SERVICE INFORMATION

NO : 8
TITLE : Key/mainboard B and B-HW series
MODEL : All B-HW round filter machines from May 2013
DATE : 01-05-2013

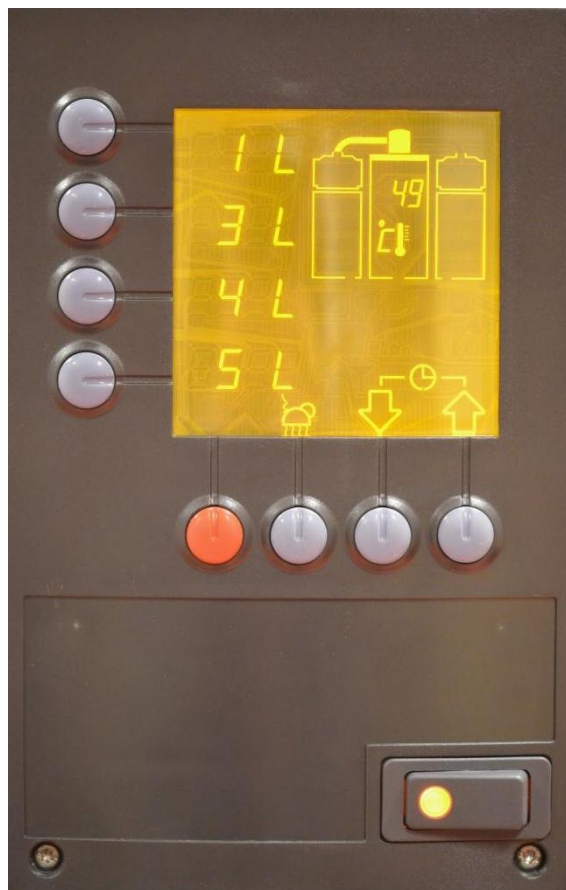
Due to the fact that the display of our round filter machines is not available anymore we are forced to provide the B and BHW columns with a new display.

Due to this we changed the colour of the display to orange and black which improves the visibility of the display. Also the timing of error 3 in the software is adjusted to prevent the machine giving unnecessary error 3 codes.

If you have an old machine and wish to build in a new type of keyboard or mainboard, then this is only possible if you replace both keyboard and mainboard and mount a new flatcable.
